# SERVICE BULLETIN SB00.16

**Machines/Models:** LX31/41/50 2WD **Serial Numbers:** 2747 -3755

**PURPOSE:** Enhance Brake Durability

**Figure 1**

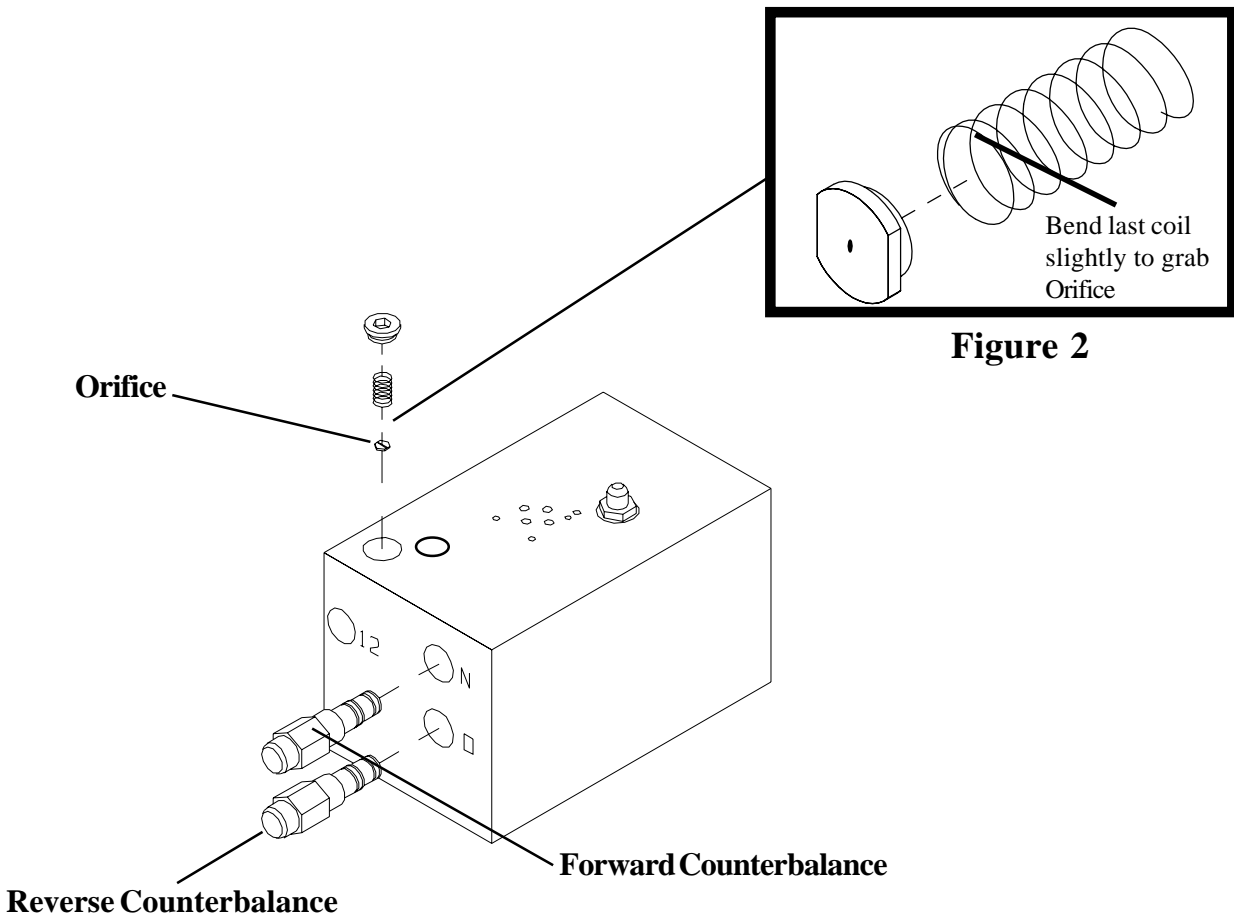
**PROCEDURE REQUIRED:** Install Orifice and Spring, adjust the Counterbalance Valves

1. Locate the Forward (Reverse) Counter Balance Valve (see Figure 1).
2. Loosen the locknut.
3. Turn the valve clockwise until it gently rests against the seat.
4. Turn the valve counter clockwise 2 1/4 turns.
5. Torque the locknut to 3 Ft. Lbs (4 Nm).
6. Repeat steps 1 through 5 for the Reverse Counter Balance Valves as follows.

1. Locate port in the top of Main Hydraulic Manifold and remove the plug (a blunt tap with a small hammer on the top of the plug will ease removal)(see Figure 1).
2. Using the supplied spring and orifice bend the spring slightly to secure to the orifice (see Figure 2) .
3. Insert the spring and orifice in the valve block (see Figure 1).
4. Reinstall the Plug and torque to 10 to 20 Ft. Lbs (13-26 Nm).
5. Perform Pre-Operation and Safety Inspection as instructed in the Operator Manual to ensure proper operation of machine.
